■ ENGINE MOUNTING

1. General

2. Front Engine Mount

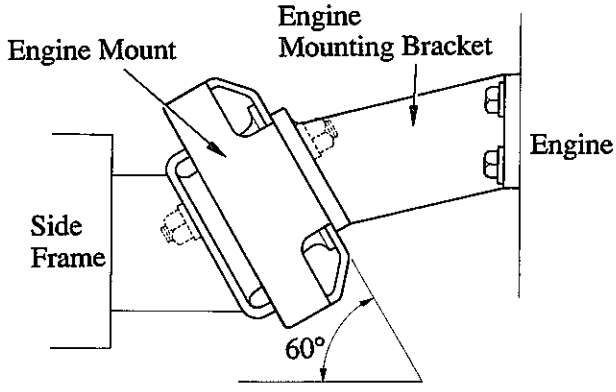
The front engine mounts are basically the same as those of the previous model. However, their optimized rubber characteristics and changed mounting angle result in a quieter vehicle with smaller and lighter engine mounts.

3. Rear Engine Mount

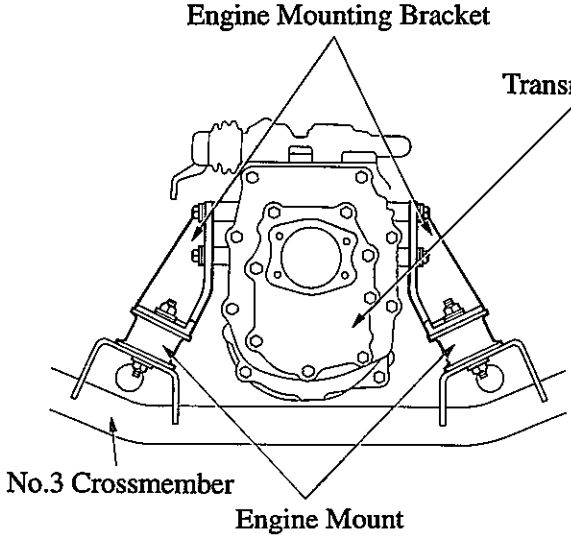
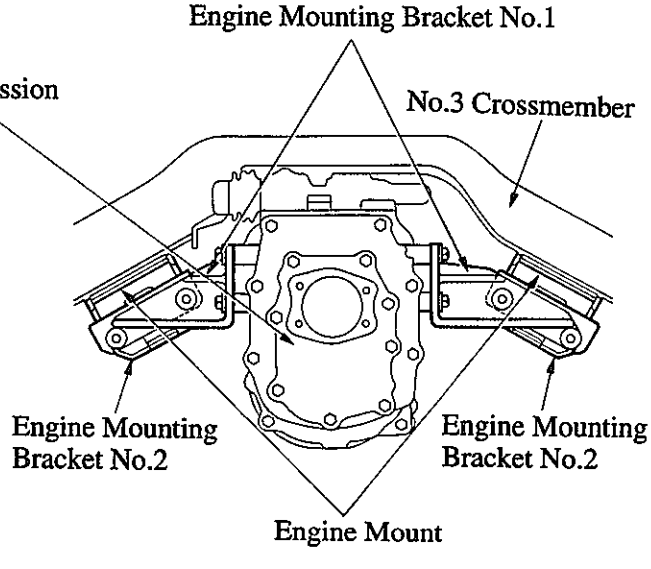
Instead of being suspended from the No.3 crossmember as done previously, the rear engine mounts of the new Coaster are placed above the No.3 crossmember. Thus, the No.2 rear engine mounting brackets have been discontinued, reducing the vehicle weight. Their rubber characteristics have also been optimized to reduce vibration.
